Access Compliance Report

Public Rights-of-Way

(Curb Ramps)

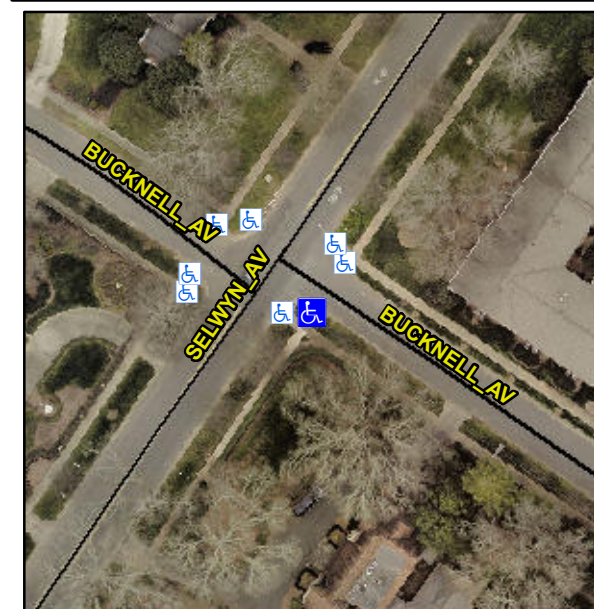
Not Found, R304.2.2

Compliance	Description	Data	Compliance	Description	Data
N/A	Ramp Length (in)	89.0	No	Ramp Slope (%)	10.9
Yes	Ramp Width (in)	53.0	Yes	Ramp XSlope (%)	1.4
N/A	Flare Type LT	N/A	N/A	Flare Type RT	N/A
N/A	Flare Slope LT (%)	N/A	N/A	Flare Slope RT (%)	N/A
N/A	Flare Traversable LT?	N/A	N/A	Flare Traversable RT?	N/A
N/A	Landing Length (in)	N/A	N/A	DWS Provided?	N/A
N/A	Landing Width (in)	N/A	N/A	DWS Contrast?	N/A
N/A	Landing Slope (%)	N/A	N/A	DWS Length (in)	N/A
N/A	Landing X Slope (%)	N/A	N/A	DWS Full Width?	N/A
N/A	Landing Curb? (Y/N)	N/A	N/A	DWS Offset (in)	N/A
N/A	Shared Landing?	N/A			
N/A	Gutter Ponding?	N/A	N/A	Gutter Slope (%)	N/A
N/A	Gutter Lip Ht (in)	N/A	N/A	Gutter X Slope (%)	N/A
N/A	Painted X Walk1?	No	N/A	Painted X Walk2?	N/A
	X Walk 1 Direction	To NE		X Walk 2 Direction	N/A
N/A	X Walk 1 Width (in)	N/A	N/A	X Walk 2 Width (in)	N/A
	X Walk 1 Slope (%)	4.0		X Walk 2 Slope (%)	N/A
	X Walk 1 X Slope (%)	1.3		X Walk 2 X Slope (%)	N/A

Remove & Replace Entire Ramp.
